Project: IEEE P802.15 Working Group for Wireless Personal Area Networks (WPANs)

Submission Title: [Comment Resolution – Illustrations for MPM Related Comments]

Abstract: [This document intends to resolve comments received in LB67]

CID 116

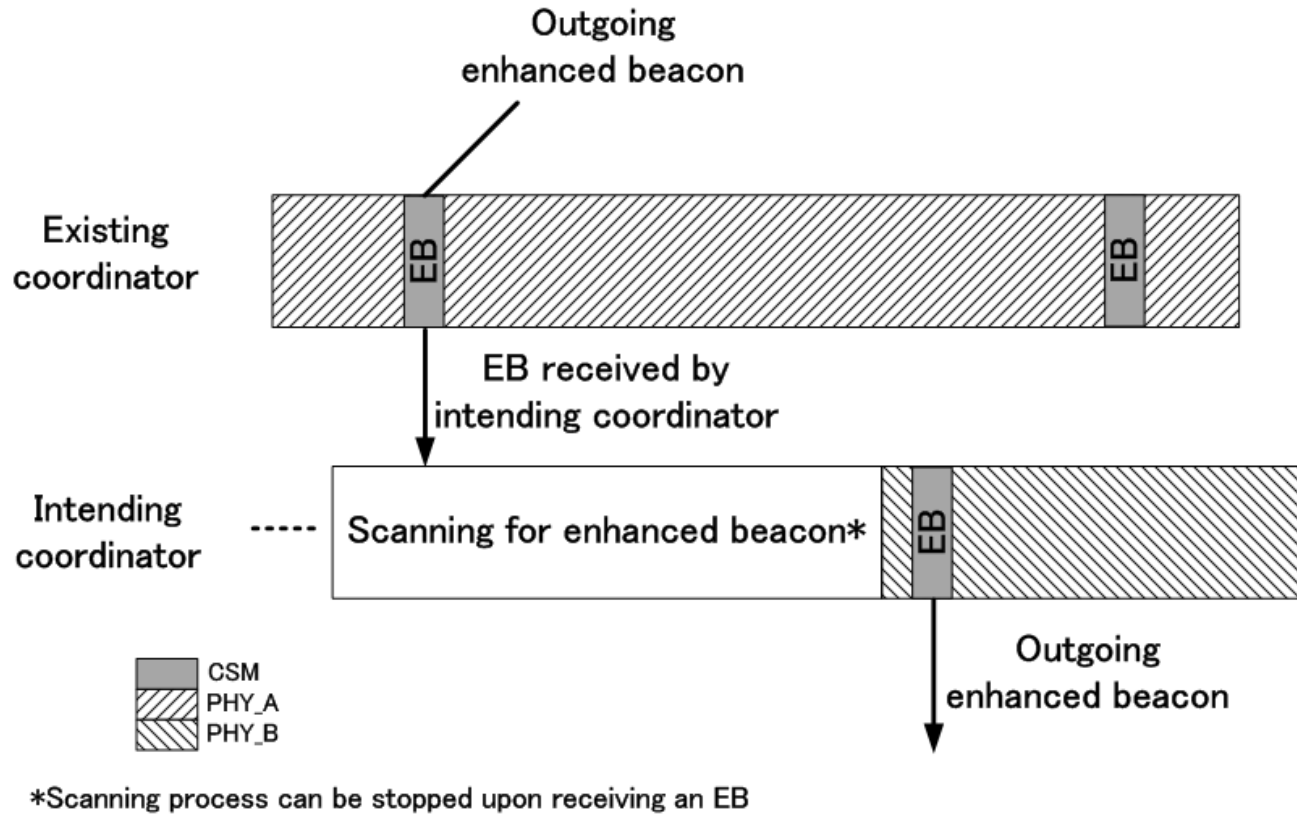
CID 406
